STATE OF CALIFORNIA  
REGIONAL WATER QUALITY CONTROL BOARD  
SAN FRANCISCO BAY REGION

STAFF SUMMARY REPORT (John Madigan)  
MEETING DATE: July 12, 2017

**SUBJECT:** **Lehigh Southwest Cement Company and Hanson Permanente Cement, Inc., Permanente Plant, Cupertino, Santa Clara County – Amendment of NPDES Permit and Cease and Desist Order**

**RESPONSE TO WRITTEN COMMENTS**

# ATTACHMENT 1 – FACILITY MAP

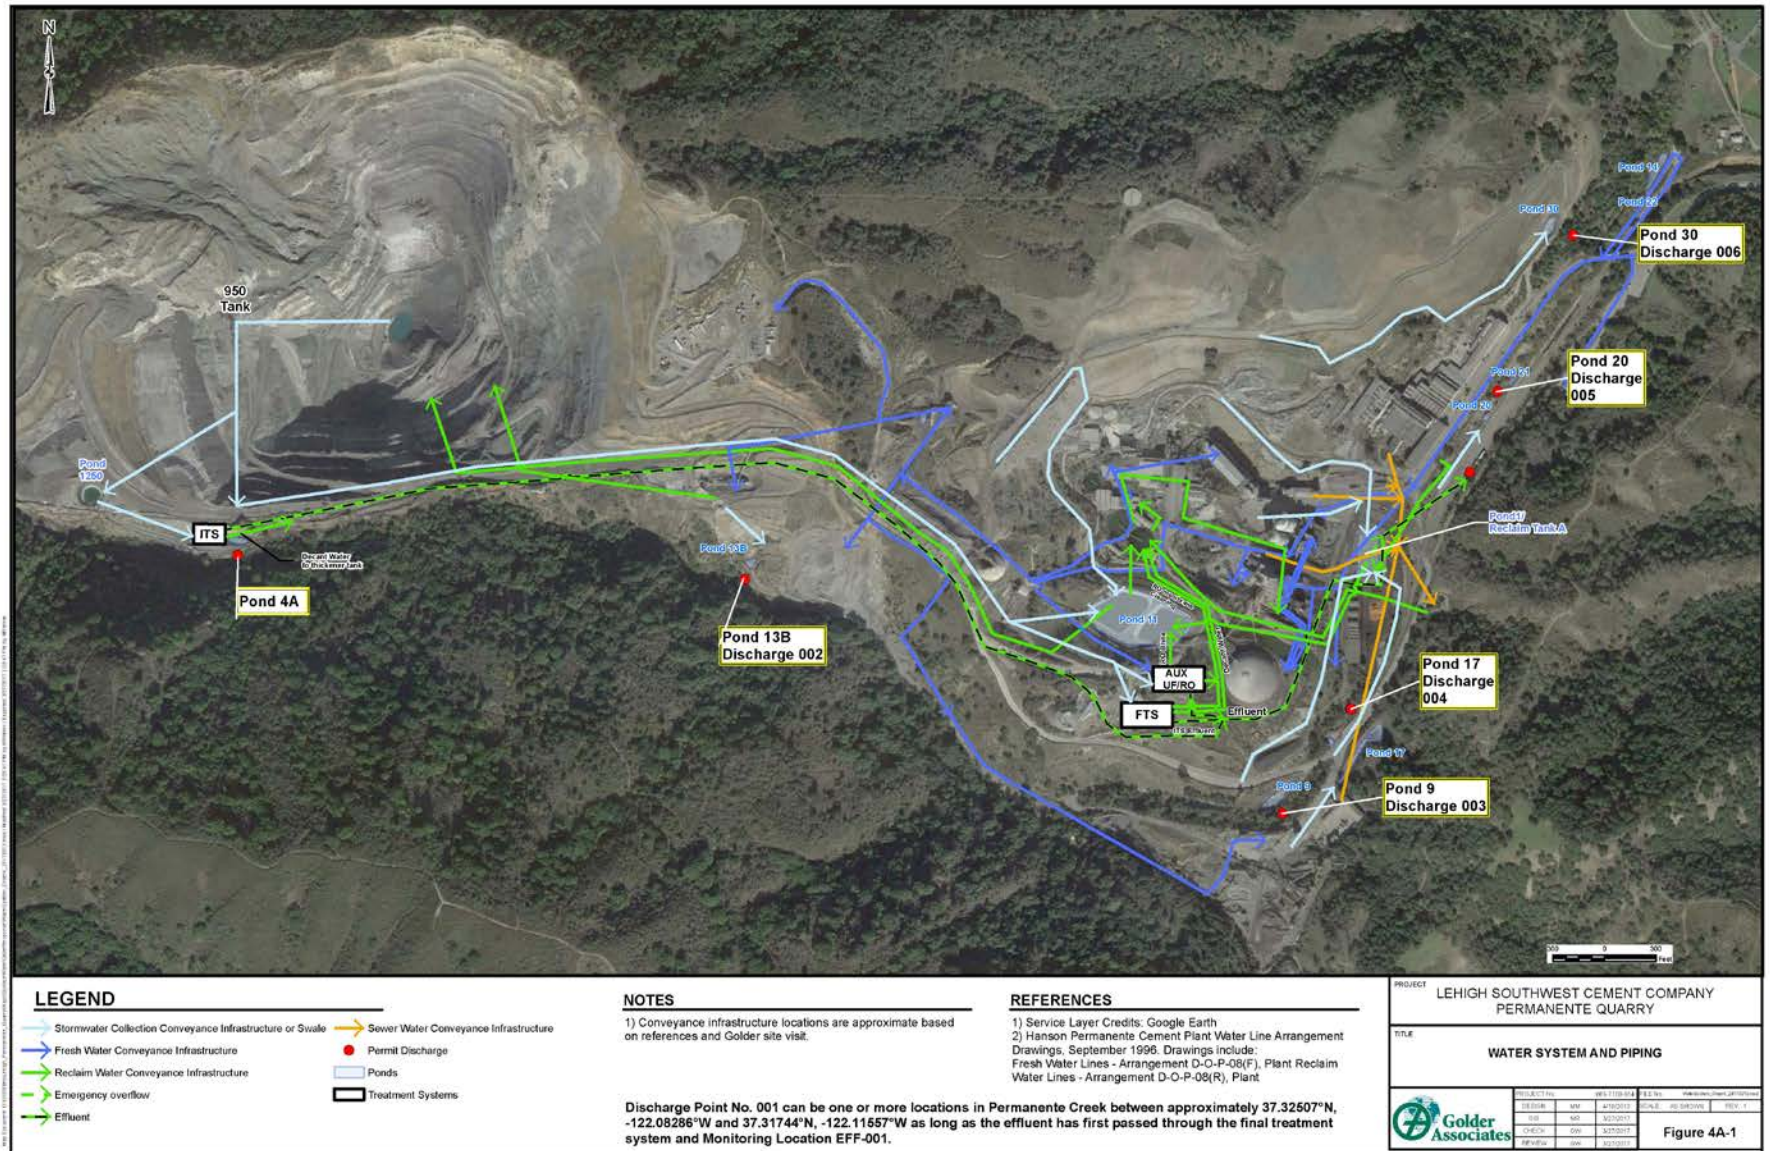
**Sierra Club Comment 1:** *Sierra Club objects to the relocation of Discharge Point No. 001 from Pond 4A to the new location approximately one mile downstream. It notes that Lehigh's mining operations depress the groundwater gradient, drawing water from Permanente Creek into the quarry pit. Thus, a significant portion of the flows treated by the final treatment system (and discharged at Discharge Point No. 001) comes from water formerly in the creek at higher elevations. Sierra Club requests that treated water be discharged to approximately the same location and elevation where it was removed.*

Finally, we revised the Facility Maps (Attachment 2 of the tentative permit amendment and Attachment 1 of the tentative CDO amendment) to include the following text:

# ATTACHMENT 2 – REVISED FINAL PROCESS FLOW DIAGRAM

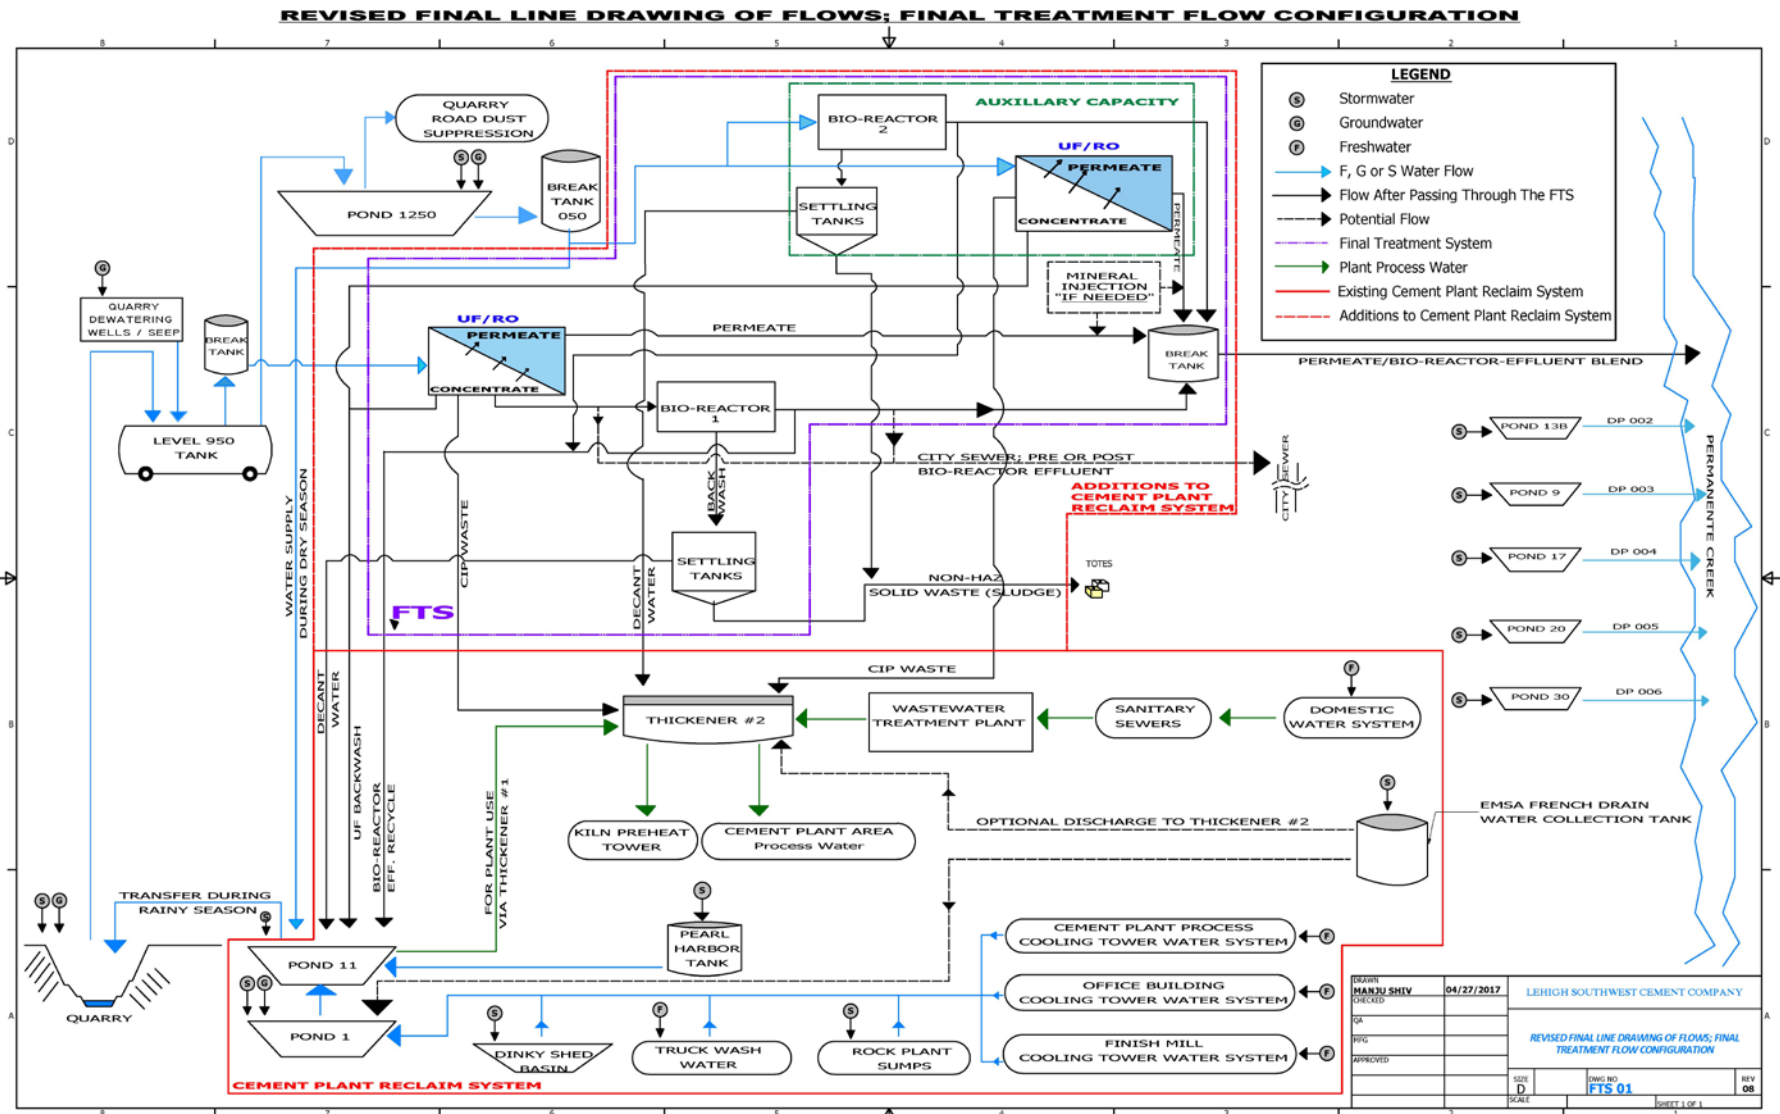
**Sierra Club Comment 2:** *Sierra Club requests that the Regional Water Board not allow Lehigh to discharge final treatment system effluent directly to the city sewer, as indicated in the Revised Final Process Flow Diagrams. Sierra Club states that this water could significantly reduce downstream Permanente Creek flows, raise creek temperatures, and reduce the creek's contribution to Santa Clara Valley's underground drinking water supply.*

**Response:** The tentative permit amendment cannot authorize discharge to the city sewer system because the Regional Water Board does not have jurisdiction to do so. The city must authorize such discharges. The flow diagrams simply recognize the possibility of such authorization. However, diversion to the sanitary sewer of flows sufficient to harm downstream Permanente Creek reaches or to significantly reduce groundwater percolation is unlikely due to the logistics and cost of re-routing discharges to the sewer system.

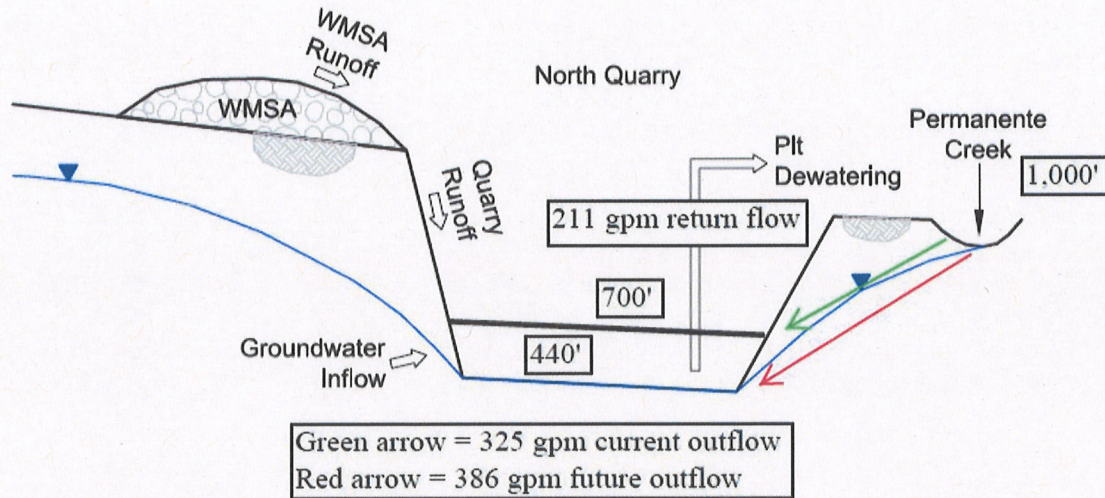
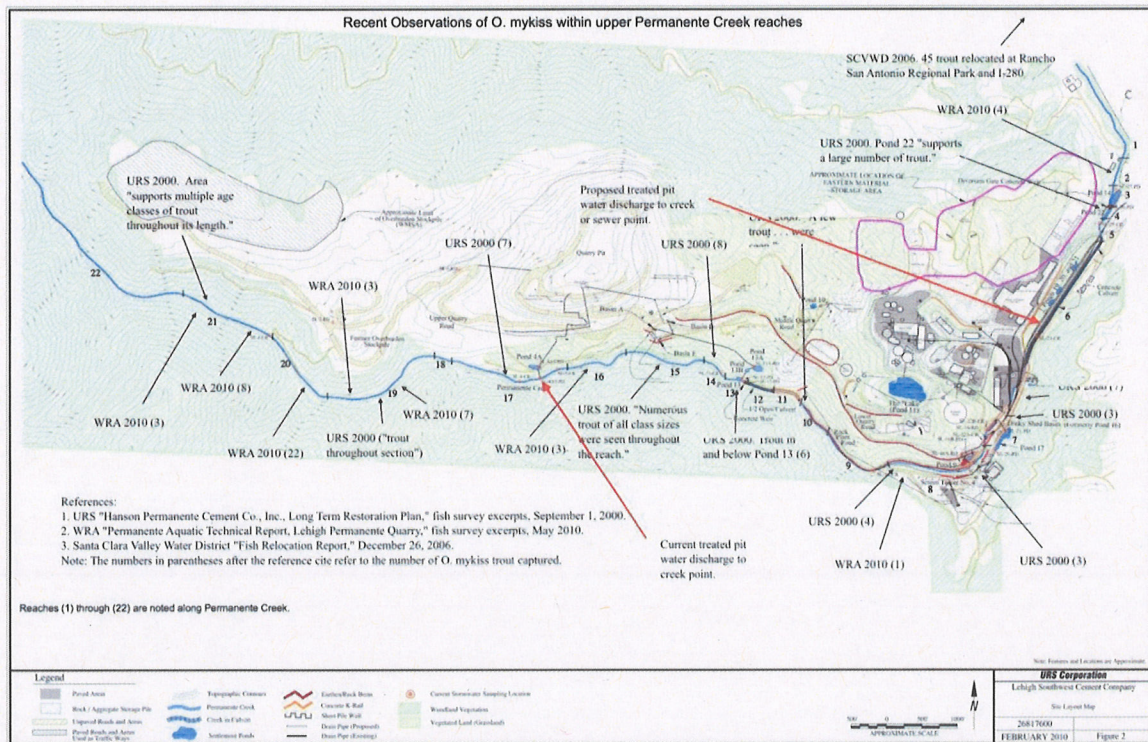
Lehigh seeks to change the FTS discharge point in its NPDES permit from Pond 4A, at an elevation of ~1,080 feet, to a new location approximately one mile downstream at an elevation of ~500 feet. Lehigh letter to Regional Water Board, December 30, 2016. The requested change in location appears to be inspired by an interest in lowering pumping costs.

Lehigh's request should be rejected; Lehigh's current Pond 4A discharge point should be retained. That point, shown in relationship to the Lehigh quarry, is shown below.

A graphic explaining how creek drawdown from pit dewatering is at least partially counter-balanced by the re-introduction of treated pit water, is shown below:

To what extent would Permanente Creek be deprived of FTS treated water return flows if Lehigh's request to change the point of discharge from Pond 4A to the cement plant location? The map below indicates at least a mile of creek would be adversely affected. Not only would resident fish be harmed by this significant reduction in flow between Pond 4A and the cement plant, but all related species and riparian habitats.

**Response:** We agree that some of Lehigh's discharge may be necessary upstream to support Permanente Creek aquatic habitat beneficial uses prior to filling the pit and restoring the creek. We revised the tentative orders (1) by revising the definition of Discharge Point No. 001 to authorize discharge throughout the stretch of Permanente Creek adjacent to the Lehigh site, and (2) by adding a permit provision requiring Lehigh to determine the minimum flows needed to protect existing aquatic habitat beneficial uses and to provide those flows as necessary.

REVISED FINAL LINE DRAWING OF FLOWS: FINAL TREATMENT FLOW CONFIGURATION

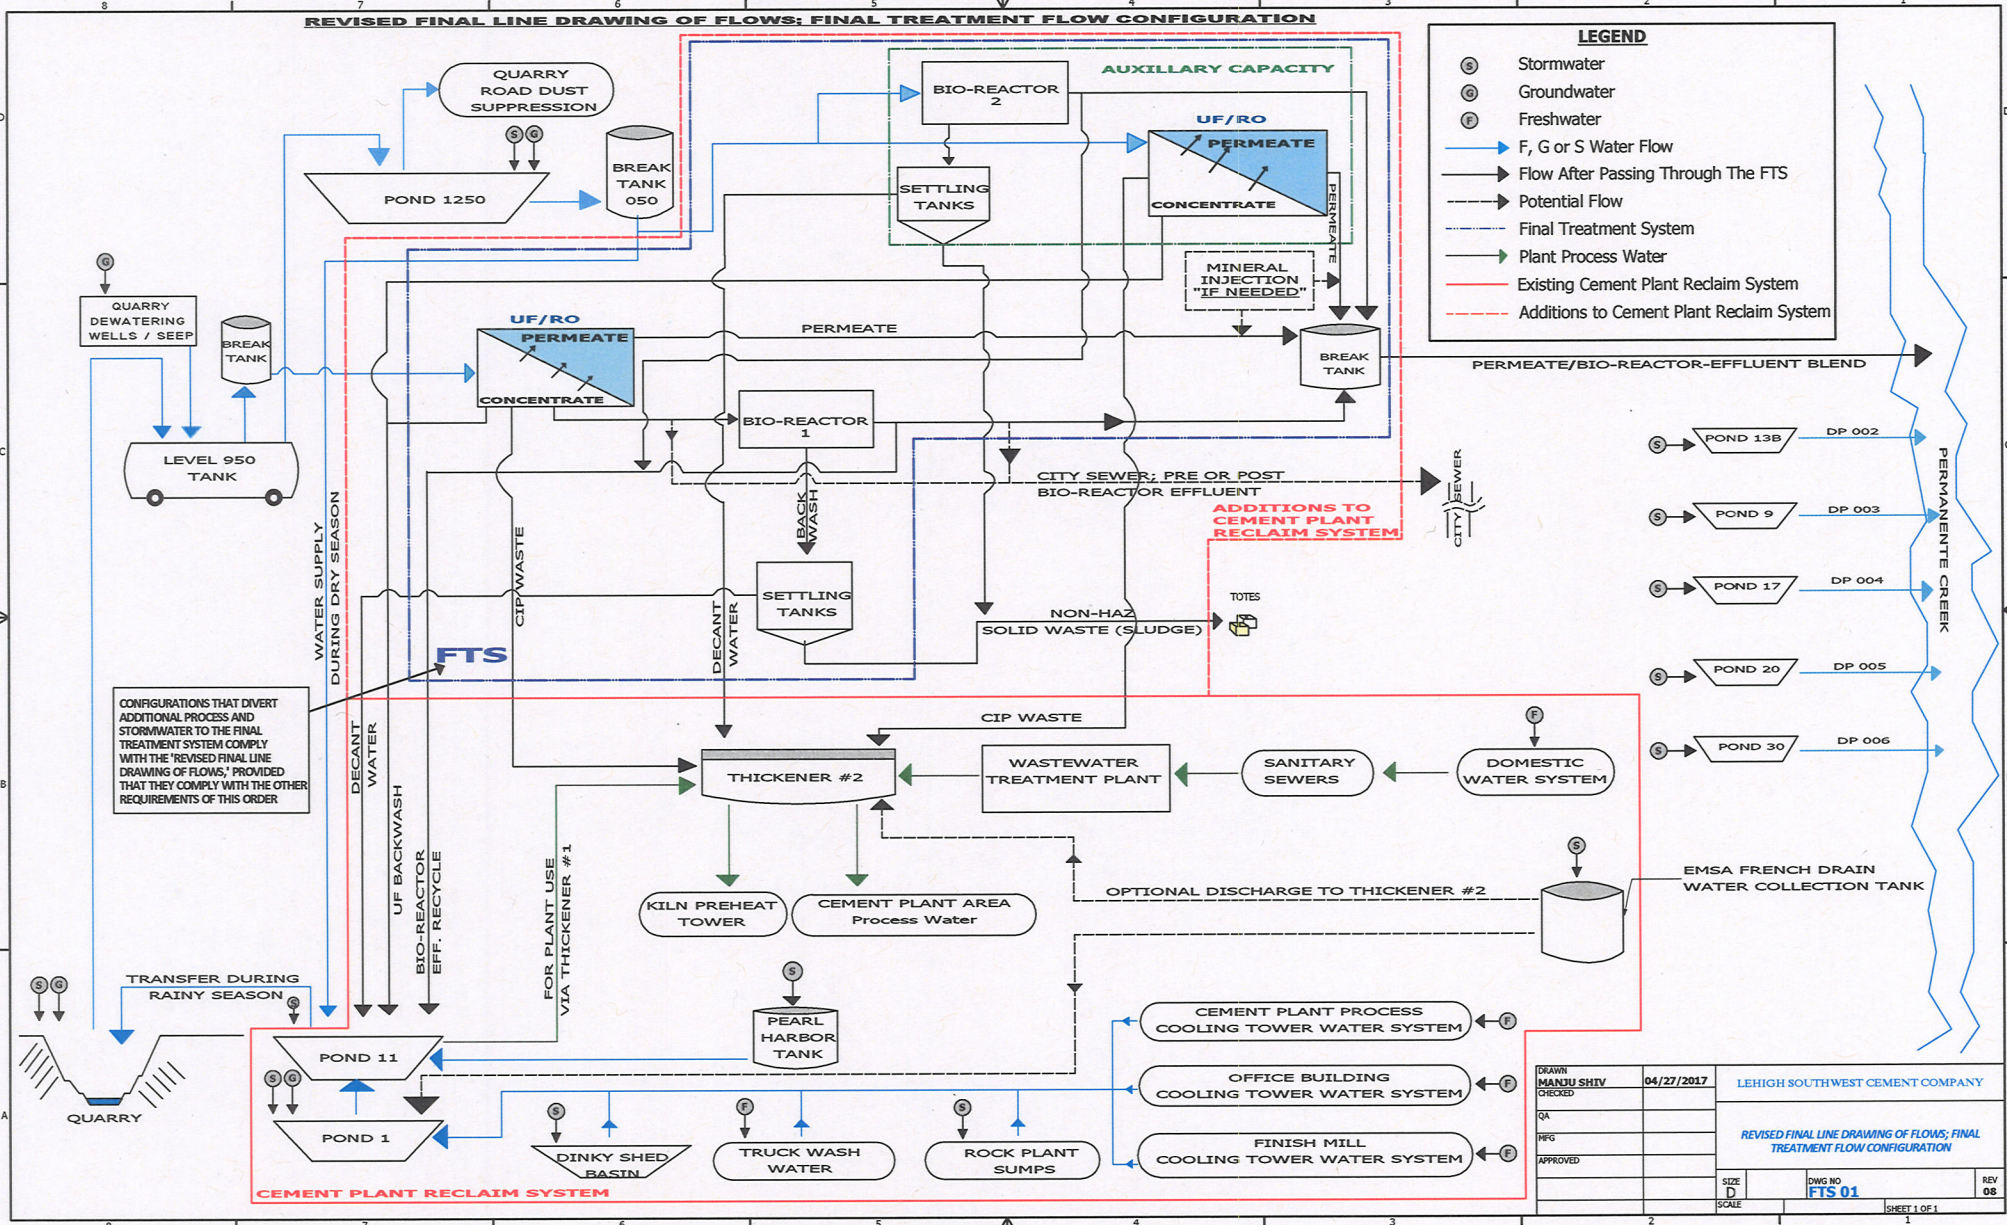
Thank you for the opportunity to comment. Lehigh noticed that the "Pearl Harbor" tank was inadvertently omitted from the final flow configuration line drawing, and submits a revised figure here, with Pearl Harbor noted (as a source of storm water flows within the Cement Plant Reclaim System), simply for accuracy (no substantive change). Further, Lehigh now has more exact coordinates from which it plans to sample EFF-001 (Table E-1), page 4 of the permit amendment (N 1942091.8, E 6099830.2), please let us know if you would like further details for inclusion in the documents prior to the Regional Water Board hearing.

**Lehigh Comment 1:** *Lehigh comments that the “Pearl Harbor” tank was inadvertently omitted from the Revised Final Process Flow Diagram and submitted a revised diagram. Lehigh notes that the Pearl Harbor tank is a source of stormwater flows within the Cement Plant Reclaim System, and that adding the label is not a substantive change but is necessary for accuracy.*

**Response:** We agree. We revised the Revised Final Process Flow Diagrams (Attachment 3 of the tentative permit amendment and Attachment 2 of the tentative CDO amendment) to include the Pearl Harbor tank.
